**Re: Initial Submission Review – King’s Point South PAs 1-4 – Site Plan and Plat**  
 Application Number: **DA-1628-04**  
 Case Numbers: **2021-4001-00**

## Initial Submission Review

**TOPOGRAPHY TOOL KIT ACCOMMODATING SLOPES ALONG STREETS**

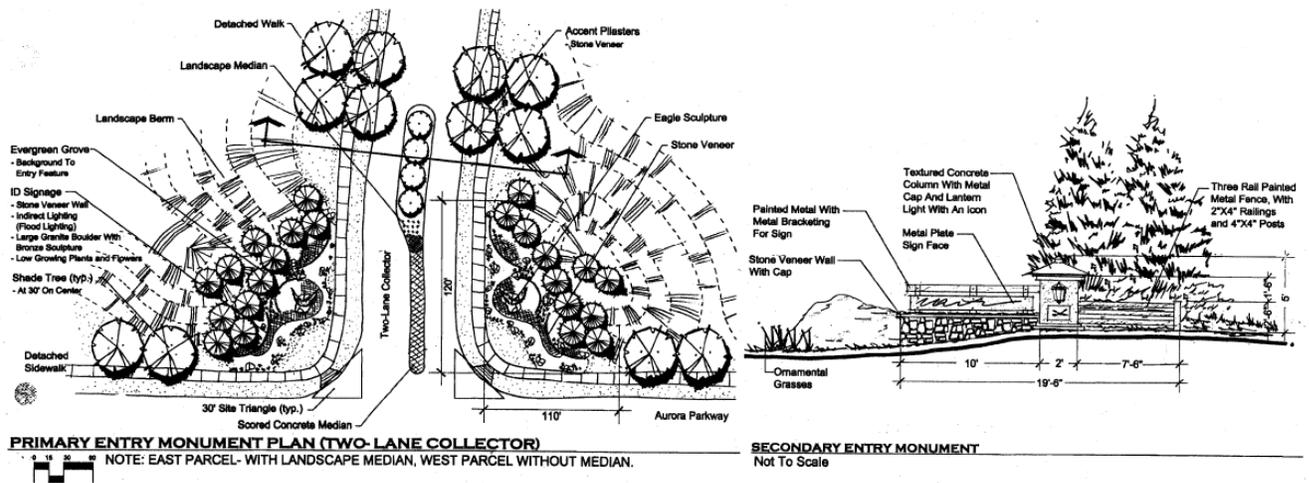
- 3A. It is suggested that you review the King’s Point South FDP for compliance with design standards, including standards relating to construction on slopes. A topographic tool kit, which requires homes to be constructed in a manner that minimizes the use of retaining walls, applies. The site plan must be redesigned to eliminate retaining walls and meet the urban design standards of the toolkit.
- 3B. Remove “Not for Construction” on all plans with the exception of the landscape plans.

- 3C. In addition to the topography toolkit, subdivision standards in the Unified Development Ordinance will be applicable to this development. Section 146-4.3.5.B requires that grading on or near ridgelines and swales shall maintain the approximate topographic Significant reconstruction of prominent topographic features shall be avoided.
- 3D. Section 146-4.3.17.A requires that parks and open space shall be located on prominent high points with significant views. The proposed park and open space at the heart of the development will advantage of the views of the Front Range meets this criterion.
- 3E. The Public Improvements Plan calls out required improvements for Phase 1 neighborhood. In this particular case, King’s Point South is required to provide a right-in, right-out connection to East Aurora Parkway when it is constructed.
